Addendum 1

Project: Hamilton-Wentworth District School Board
REFERENCE NO. 2025-107-P02082
Hess Street Elementary School Ground Floor Ceiling Replacement and
Lobby / Classroom Renovation Project

Addendum #1
Hess Street Elementary School Ground Floor Ceiling Replacement and Lobby / Classroom Renovation Project

Project: HWDSB-P2024-2082 – Hess Street ES Renovation

APPENDIX-ELECT-ADD-1

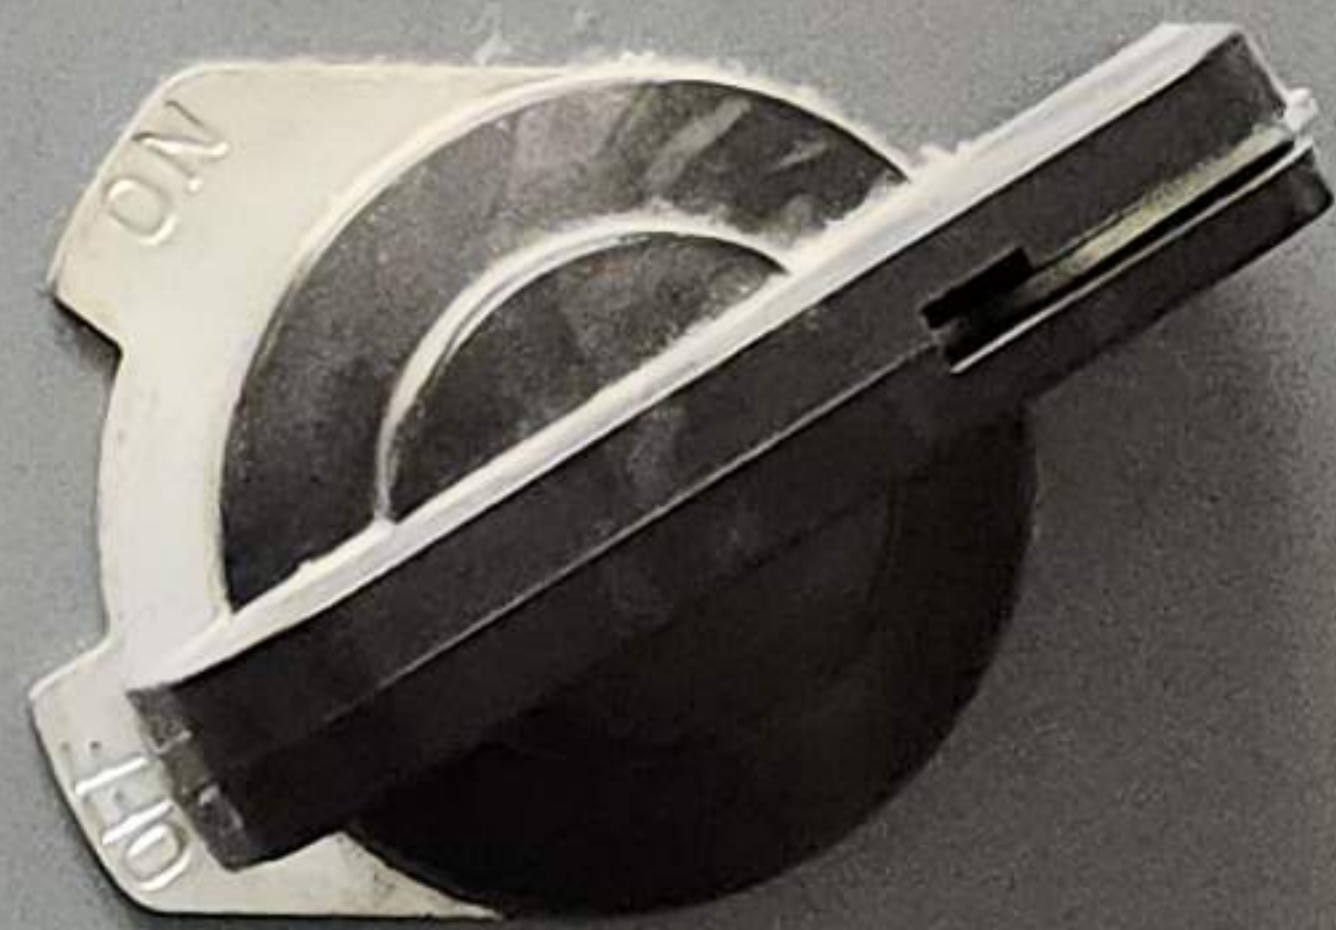
Items	Questions	Responses
1	Electrician has requested pictures of the switch board and name plates. Regarding the E-200 drawing note 5.	See attached photos in Appendix Elect-Add-1
2	We received a list of approved data caballing contractors for another HWDSB bid, could you please confirm that we can carry any data caballing contractor?	<p>Only the board approved data cabling shall be used</p> <p>COMU NETWORKS - MIKE ONEAL, 289-253-9289, MIKEJ.ONEAL@COMU.CA</p> <p>CONNEX TELECOMMUNICATIONS INC. - ED BALIAN, 905-944-6516, ESTIMATING@CONNEXSERVICE.CA</p> <p>M ARCOMM INTEGRATED BUSINESS SOLUTIONS - ADAM LUCIA, 416-938-3730, ADAM.LUCIA@TELECON.CA</p>
